Indoor Station Firmware V2.2.2_build221129

Release Note (2022-12-02)

Device Model	DS-KH8350-WTE1, DS-KH8350-TE1, DS-KH6320-WTE1, DS-KH6320Y-WTE2, DS-KH6320-WTE2(B), DS-KH6320-TE1, DS-KH8520-WTE1
Firmware Version	V2.2.2_build221129
iVMS-4200	V3.8.3.1 or later

B. Link indoor station with main and sub door station

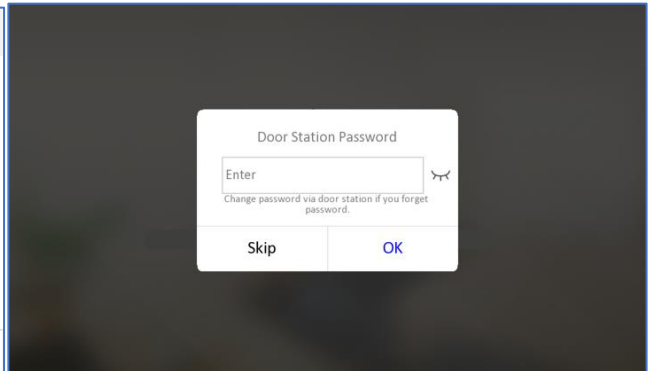
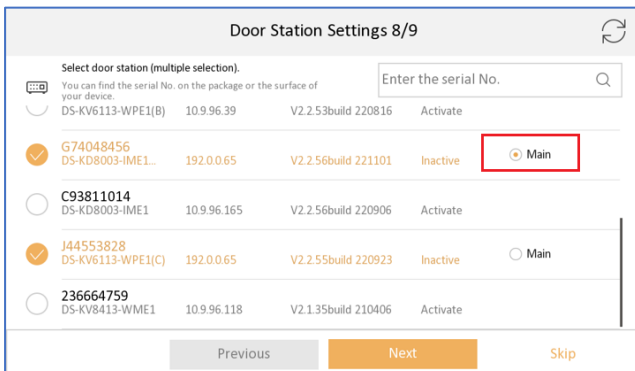
- a. the first selected will be the main door station by default, the second will be sub1, 3rd will be sub2, etc. You can also cancel and select the main door station manually.
- b. Maximum select 17 door stations at one time (1 main and 16 sub door stations)
- c. If the selected devices are not activated, indoor station will activate them with same activation and registration password, then set the IP address for them in same network segment automatically.
- d. If the door station is already activated with different password, it will prompt you to input door station password
- e. If the main and sub door station are activated with different activation password, the registration will be failed (sub door station can't call indoor station).

C. Link indoor station with indoor extension

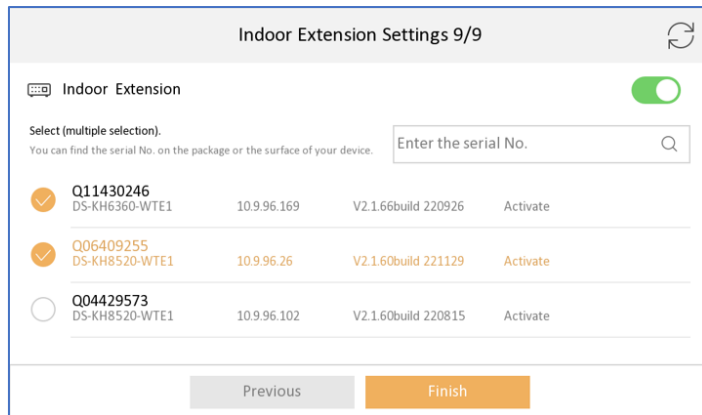
- a. The selected indoor station will be and numbered as indoor extension 1,2,3...
- b. Maximum select 5 indoor extensions at one time
- c. If the selected devices are not activated, indoor station will activate them with same activation and registration password, then set the IP address for them in same network segment automatically.
- d. If the selected devices are activated with different password, the registration will be failed (door station can't call indoor extension).

D. Pairing with main door station, sub door station and indoor extension

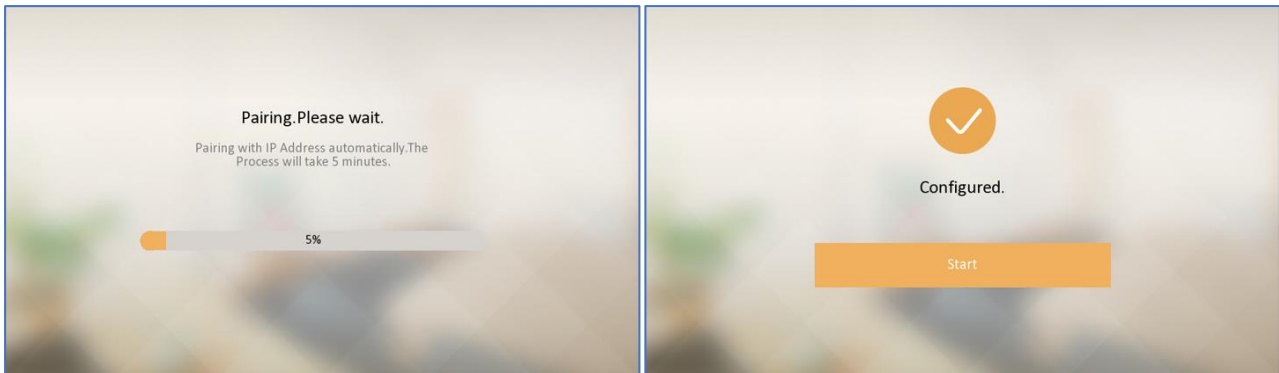
Note: The pairing time duration depends on the device quantity you selected in previous steps, it will take about up to 5 mins, please wait patiently until the process finish and show "Configured" as below.

2. Set the important parameters of door station from indoor station Menu-Advanced settings-Configuration-Device Management-Main Door Station (not from the wizard).

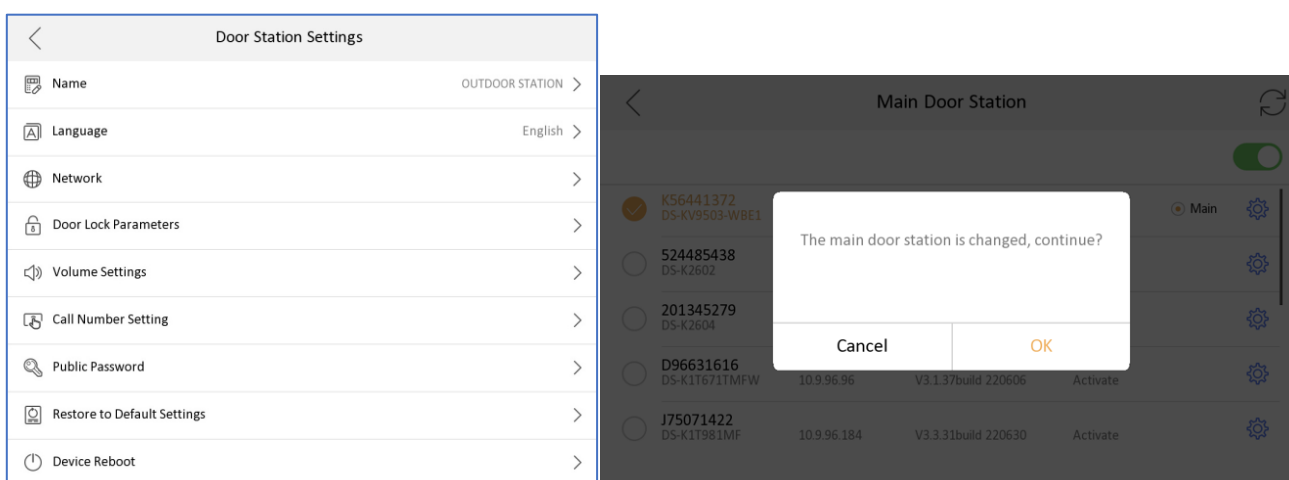
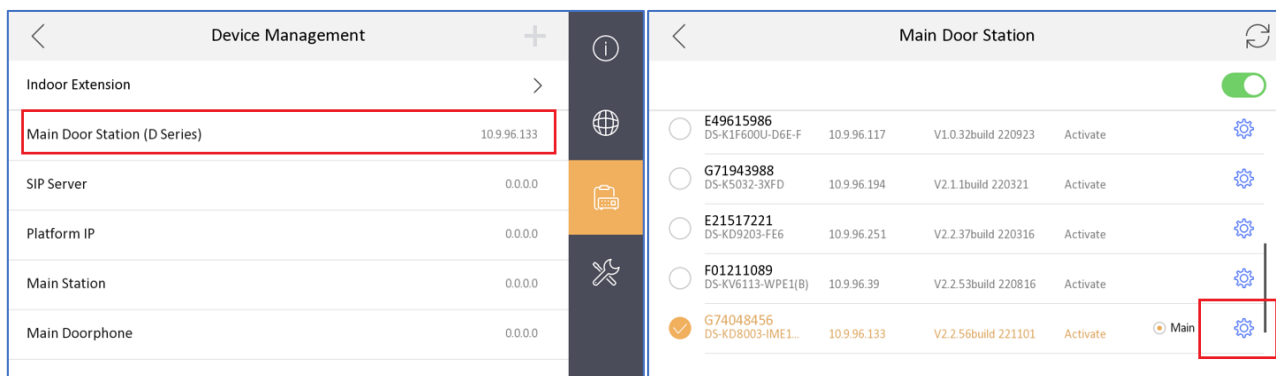
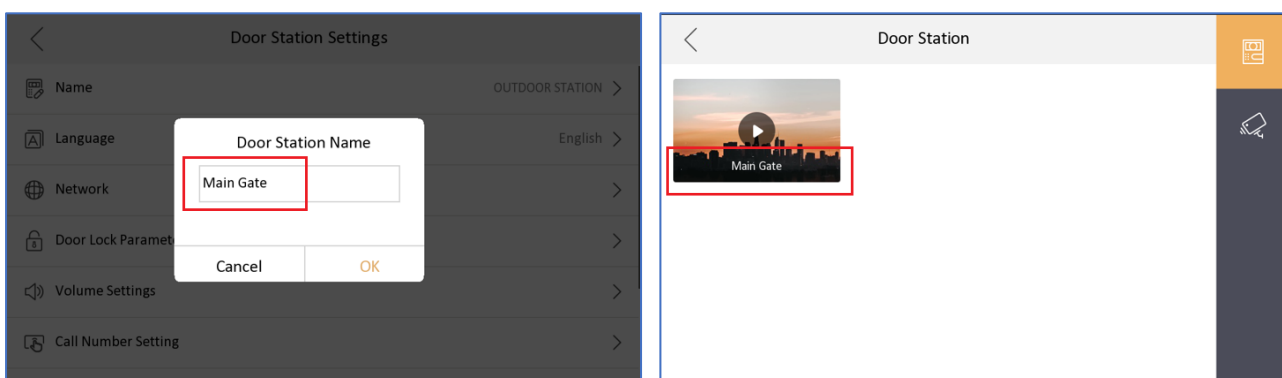
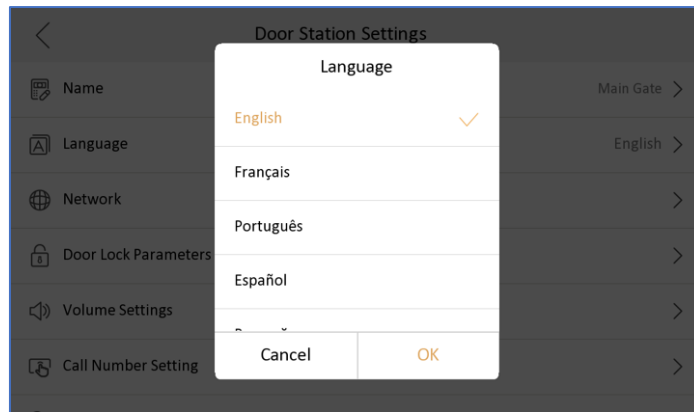
- A. You can change parameters of all door station (no matter it's linked or not) in the list by click the setting icon, see pic 2.
- B. You can also change linked main door station from this list by click device from the list, if you want to change linked sub door station, please go to Advanced settings-Configuration-

System maintenance-Wizard, and link device again.

C. After change the linked main door station, device will prompt “The main door station is changed, continue?”, see pic4 as below

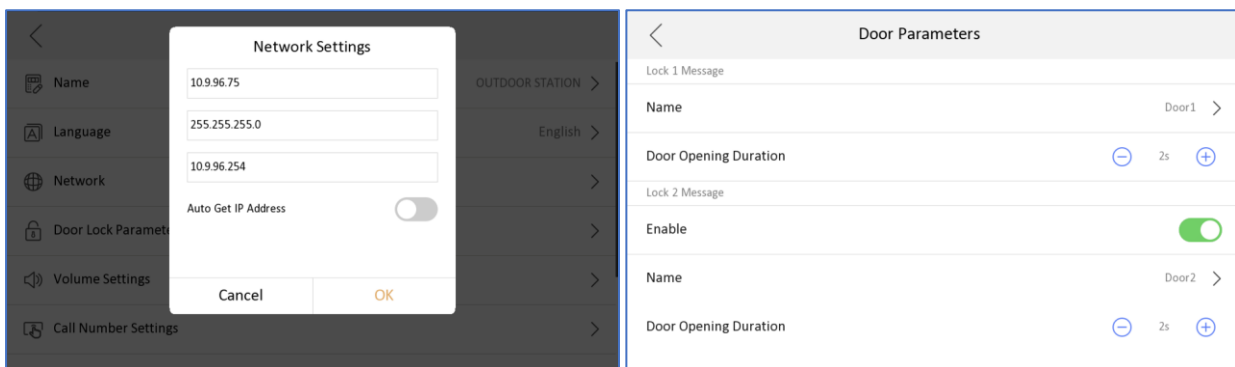
A. Set door station name (will be displayed in live view page), set door station language.

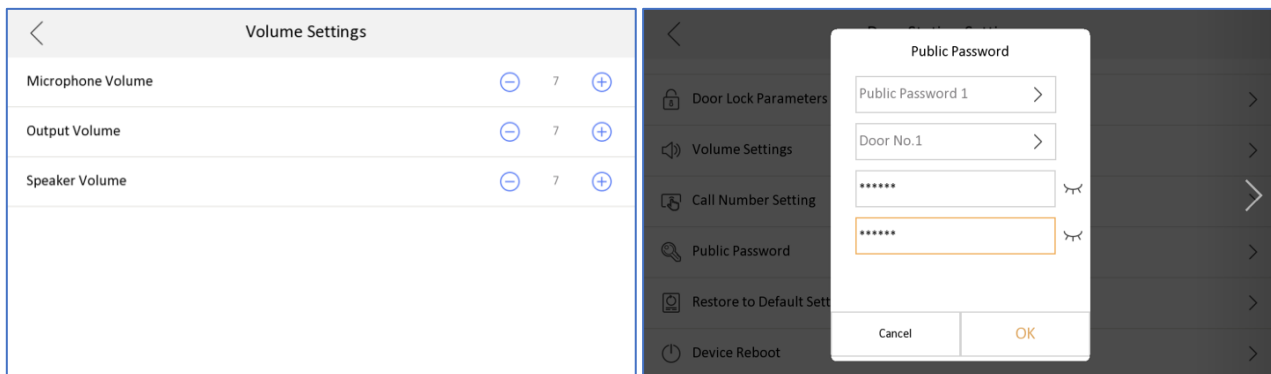
B. Set door station IP address, subnet mask, gateway, enable DHCP, lock name, door open duration, enable lock2, etc.

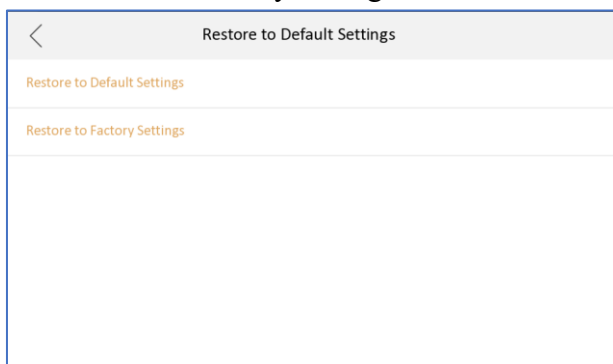
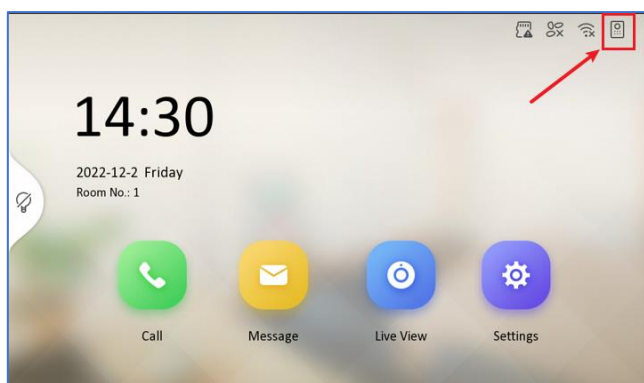
C. Door station volume setting, physical button call number, public password (lock1 or lock2)

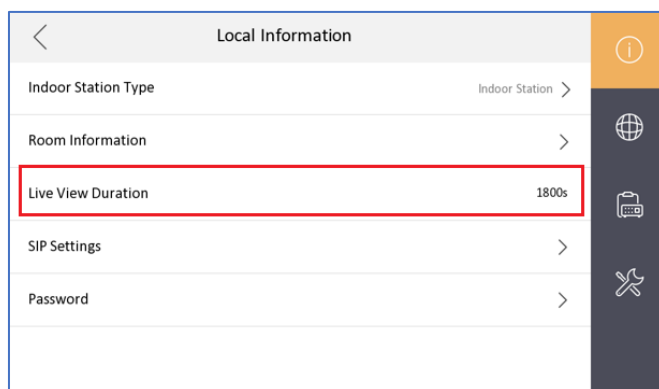
1. Optimized the icon of door station registration status in the main UI up right corner.

Note: If the door station call indoor station failed, you can click this icon  to register to door station manually, if register failed, it will indicate the reason for the failure.

Before	Now
Indoor station registers to door station success		
Indoor station registers to door station failed		
Indoor station registers to door station and KM9503 success

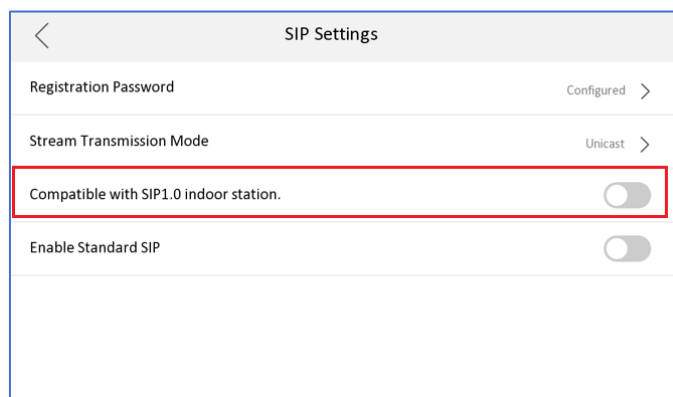
3. Support switching between protocol 1.0 and 2.0, by default it's protocol 2.0
After enable, the indoor station is compatible with protocol 1.0 indoor extension and not

compatible with protocol 2.0 indoor extension.

Note: After enable, all indoor extension of this indoor station must be protocol 1.0 firmware, don't mix protocol 1.0 and 2.0 indoor extension under same indoor station, or it will result to calling failed.

1. Optimize registration password settings in Wizard.

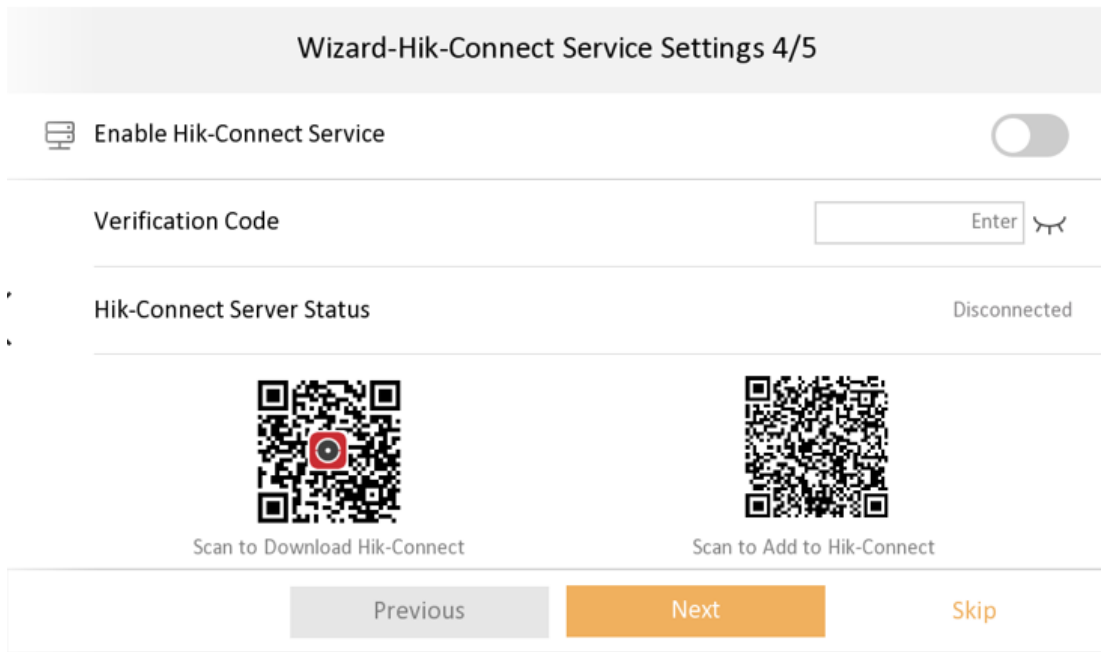
Registration Password Not configured. >
 Be consistent with the activation password.

Registration Password Not configured. >
 Be consistent with the activation password.
When enabled, the people who has the registration password will have the device admin permissions.

Wizard-Hik-Connect Service Settings 4/5

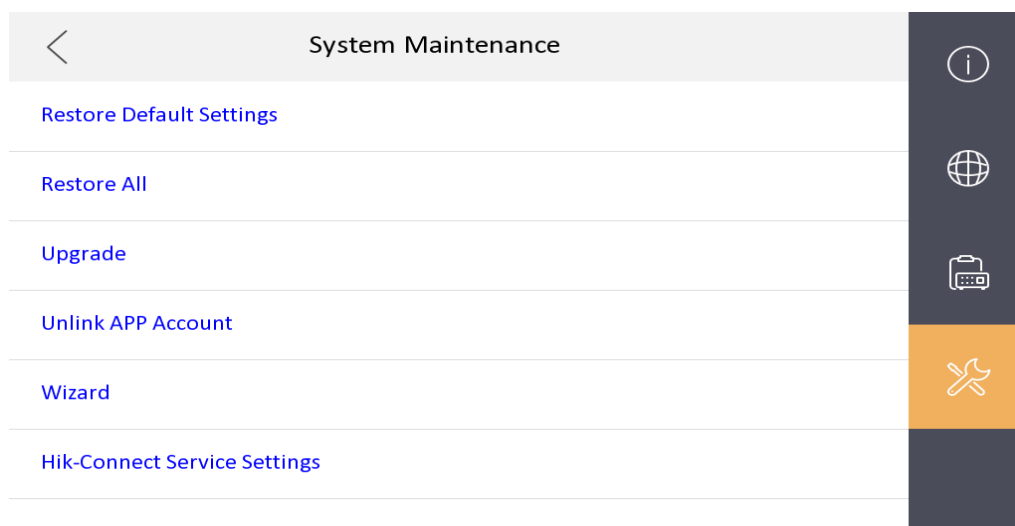
1. Verification code is empty by default.

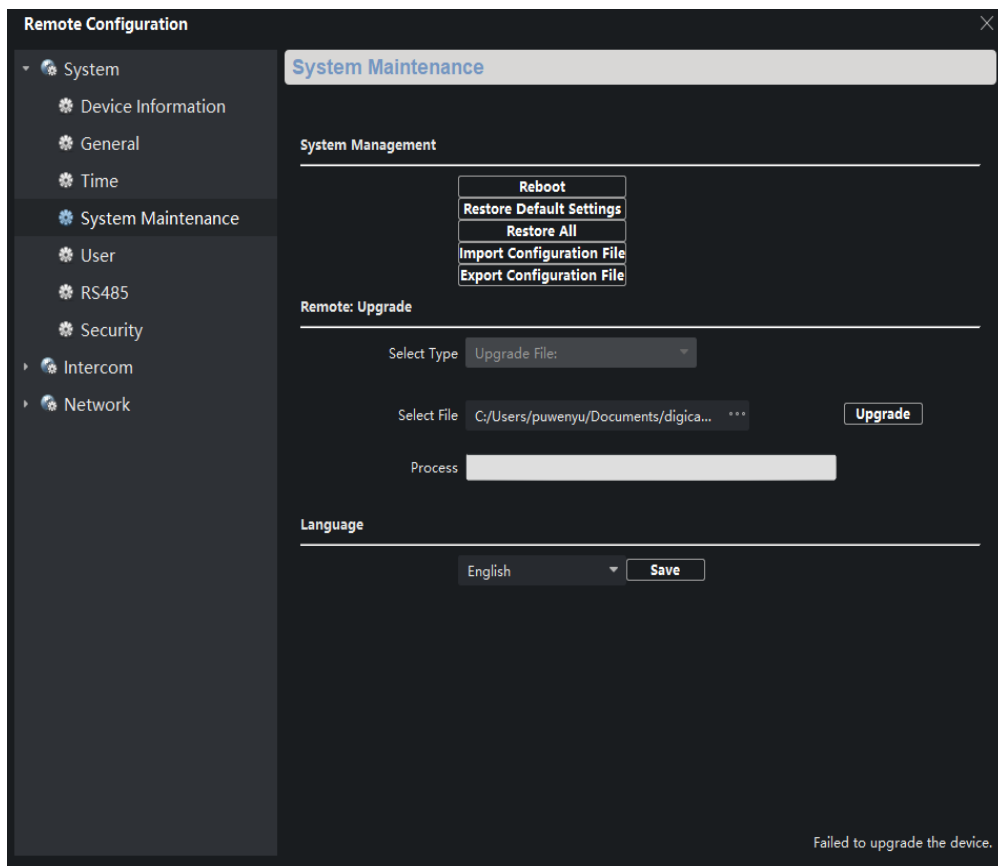
- Since **V2.1.24 build 210617**, remote

degradation of devices is not supported in all subsequent versions. When degradation occurs, it will prompt Failed to upgrade the device and the device will restart.

Notice: Although the device can be degraded by serial port, the device will fail to start and cannot change the version by using serial port again, which means that the device will be completely unusable.

**Add Device**

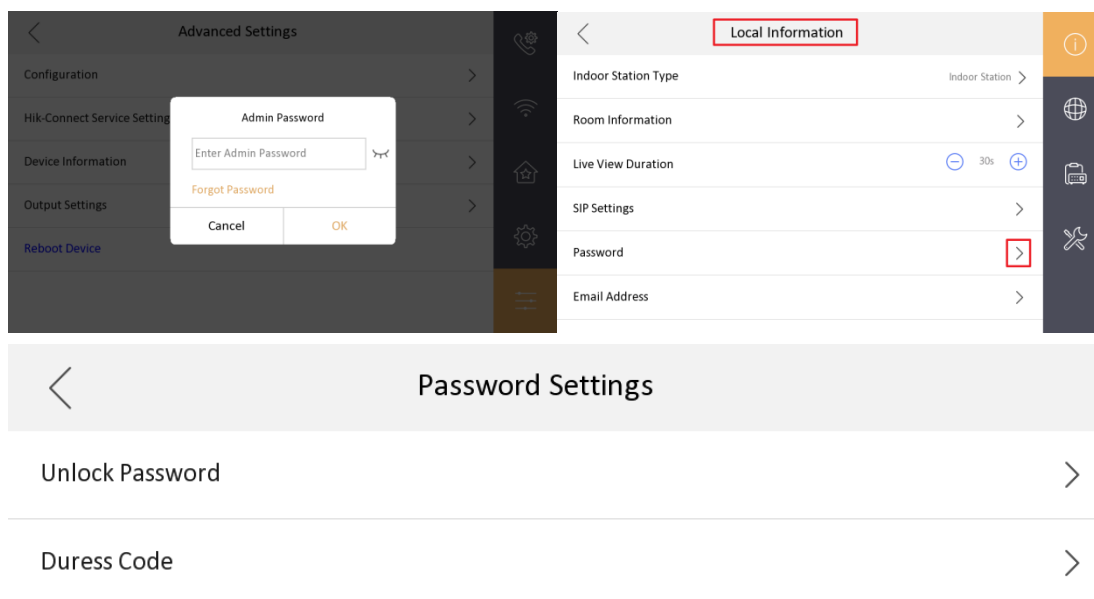
4. Add IPC interface, when Open Network Video Intercom protocol is selected, add plaintext ciphertext switch menu item configuration

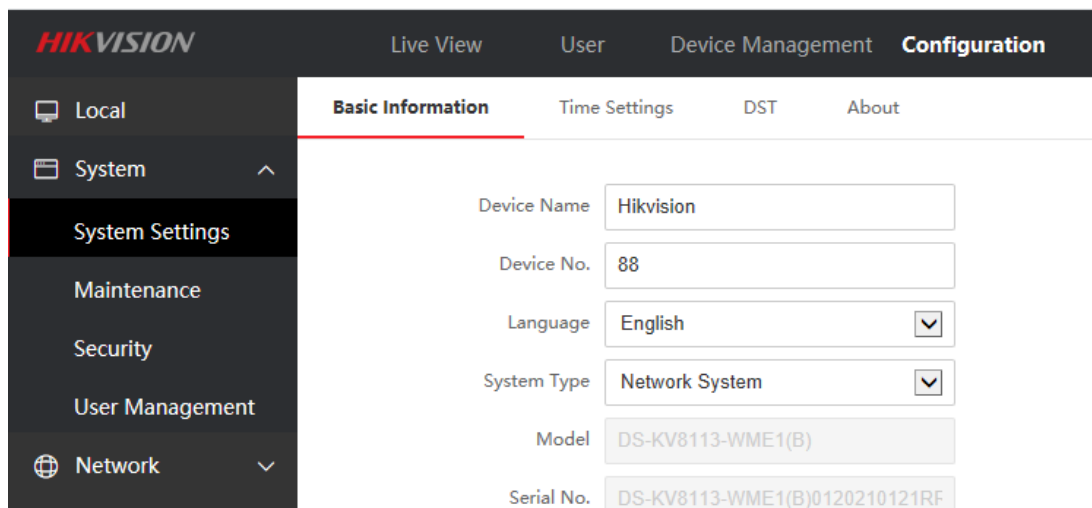
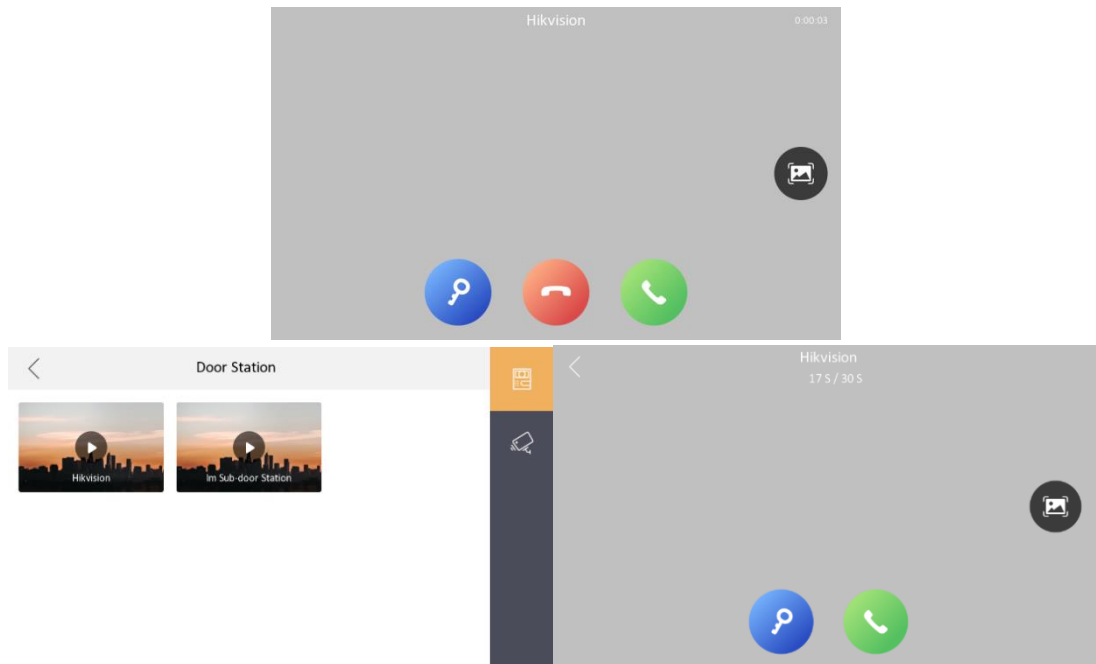
1. Change the position of unlock password and duress code, to enter the password page requires an admin (activation) password.

2. When changing the unlock password and duress code, the old password is not required as a credential.
3. The name of the local private SIP password configuration Sip Password is uniformly changed to Registration Password
4. The changed name of the door station(KD8003 modular door station, KV(-B), KB8113) will be displayed on the call interface or live view interface of the indoor station

- Higher security, SIP Passwords

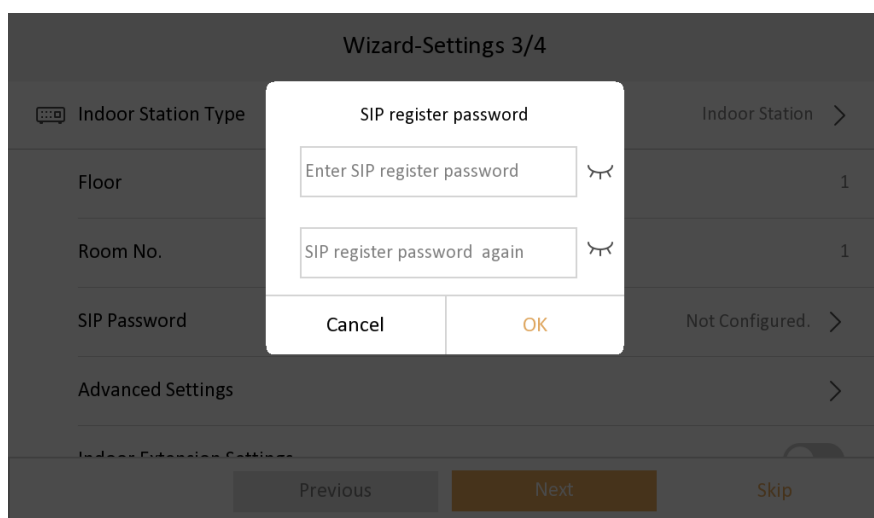
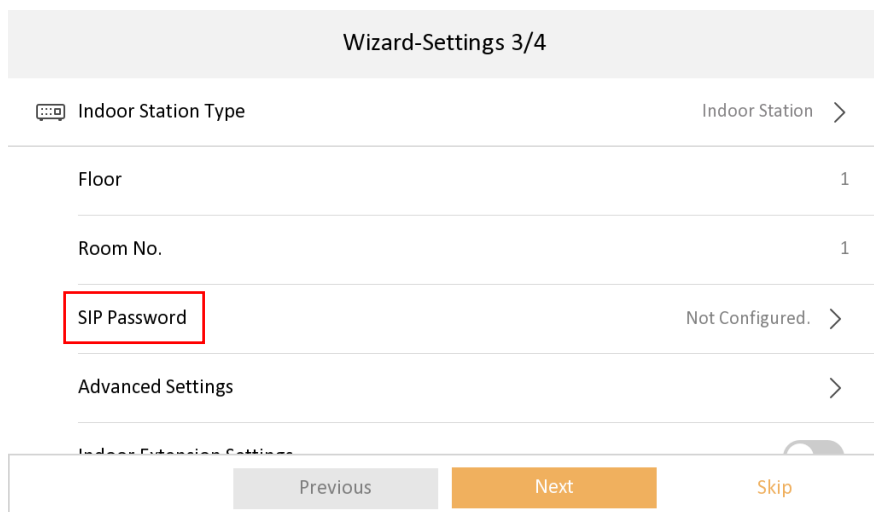
SIP password is actually Register Password, which is suitable for our security 2.0 protocol. They can communicate normally only when the **SIP passwords (Register passwords)** of the door station, indoor station and indoor extension are the **same**.
